City of
Richmond

Report to Development Permit Panel

File: DP 21-933765

Re: **Application by Interface Architecture Inc. for a Development Permit at
9300 and 9320 Cambie Road**

DP PLAN # 3a

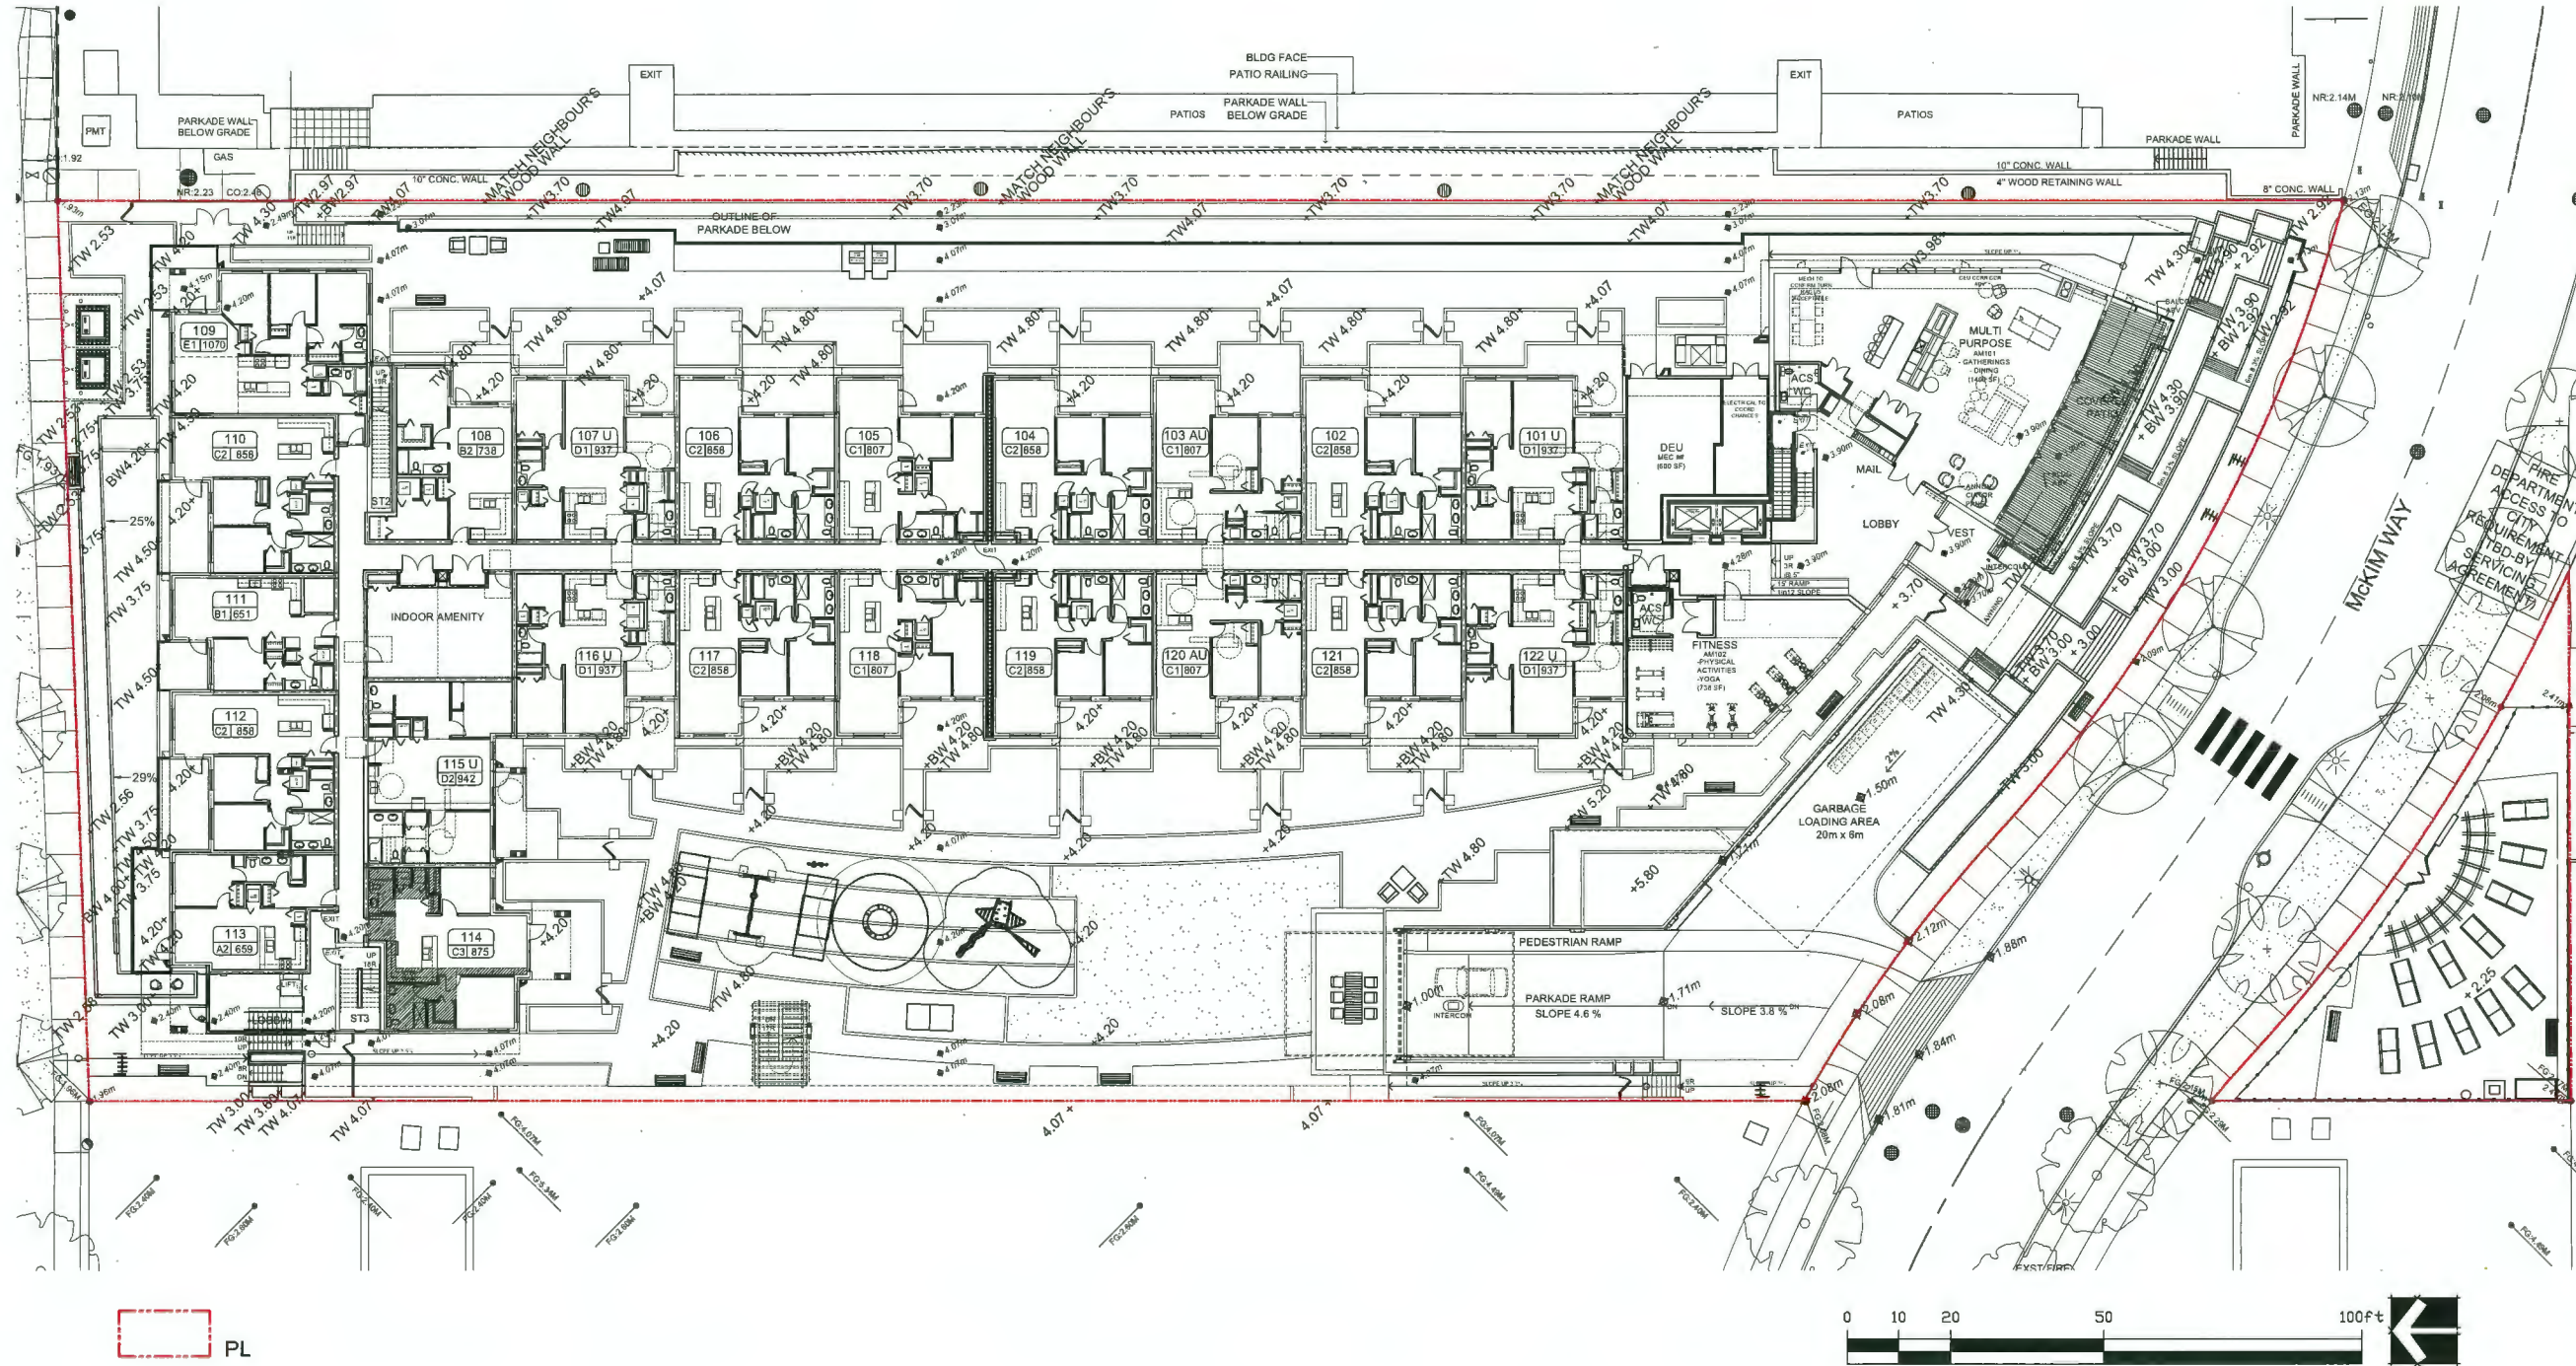
- proposed landscaping treatment for the space between the subject building and the adjacent six-storey building to the east gives rise to CPTED concerns; consider enhancing the visual openness of the space through appropriate choice of planting materials and other landscaping strategies; also consider investigating opportunities for stormwater detention;

The gap between the parkade podiums is to be landscaped with a continuous strip of shrub planting ('CC' Mexican mock orange, 'OD' false holly, see L4) on 2 tiers. There is a high degree of passive surveillance along the entire length of this gap that should alleviate CPTED concerns. Additional fencing/gating do not seem like appropriate measures but could easily be implemented by the incoming strata council. The gap between podiums does allow extensive rainwater percolation.

8 GARDEN PLOT
SCALE: 1/2"=1'-0"

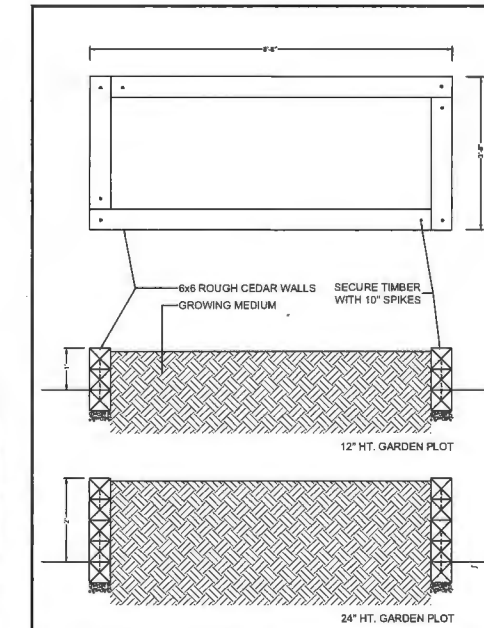
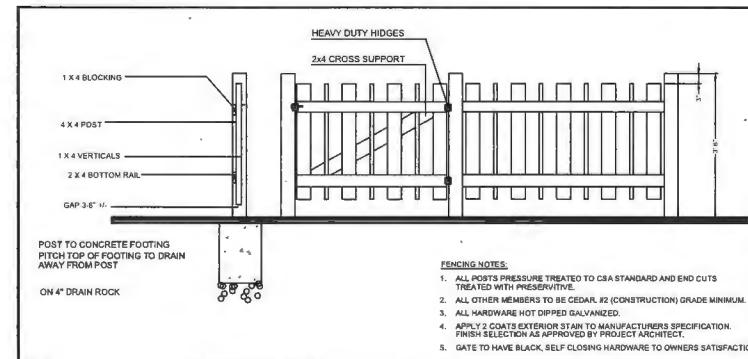
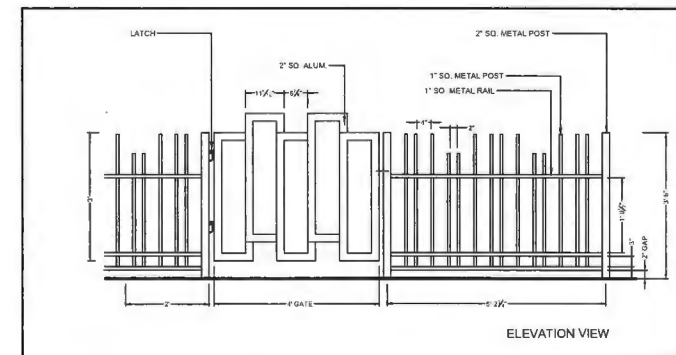
- consider including a wheelchair-accessible planting box in the community garden for residents;

- support the Panel comment that some or all of those planting boxes should be completely accessible to people in wheelchairs;

Accessibility has been incorporated (i.e. level access from the sidewalk, planter boxes with various heights, navigable surface treatment).

Planting boxes are at 2 heights (12" & 24", see sheet L8).
